UPFLOW/DOWNFLOW FAN COIL UNIT

40VU
001-006

Subject: 40HH/VU Speed Control Motors

PARTS MANAGERS BULLETIN

DIAGRAM A
Typical wiring diagram
showing speed control
in circuit.

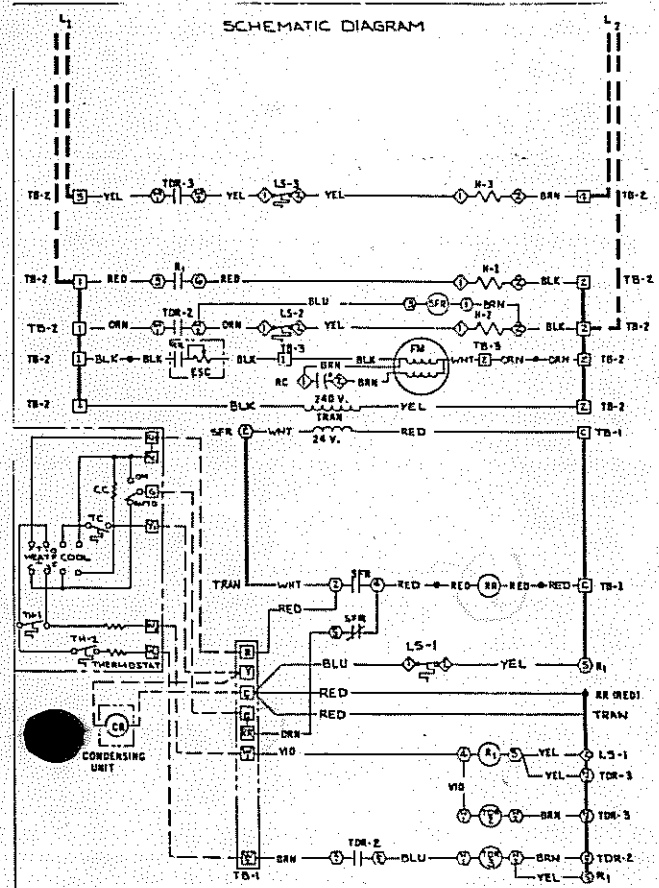
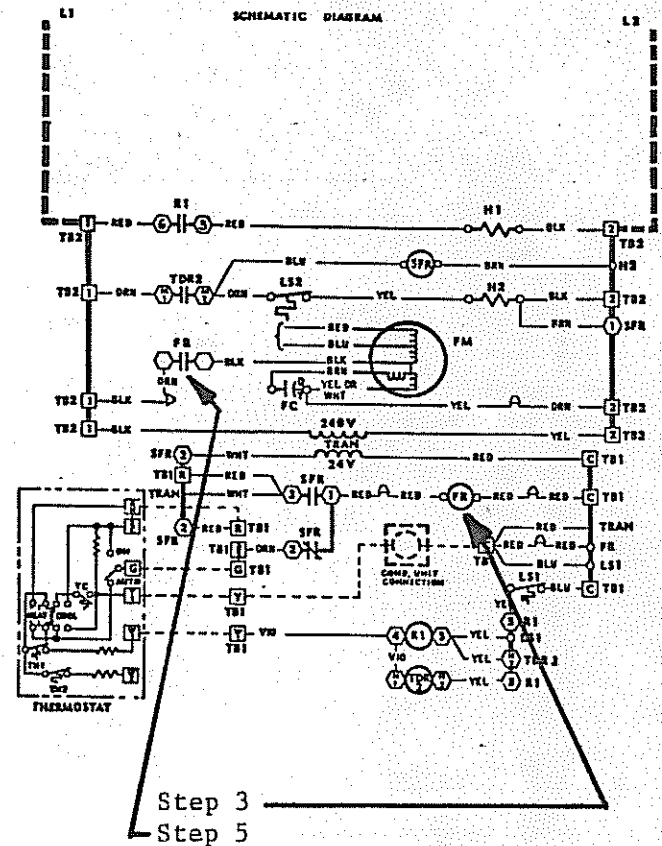
As soon as the current stocks of the 40HH/VU speed control motors are exhausted, PSD will standardize on 3 speed replacement motors. Because the replacement 3 speed motors are the "general purpose" type, special instructions cannot be packaged with the motor. Therefore, a copy of this bulletin should be filed with the 40HH and 40VU parts catalogs. This information will also appear in the Service News.

1. Disconnect speed control. Replacement 3 speed motors do not use speed control.
2. Locate in control box HN61KQ120 fan relay.
3. Connect HN61KQ120 relay coil as shown in Diagram B.
4. Select appropriate motor speed required for application. Insulate all unused leads.
5. Connect to HN61KQ120 relay normally open contacts #2 and #4 as shown in Diagram B..

DIAGRAM B
Typical wiring diagram
showing 3 speed motor
in circuit.
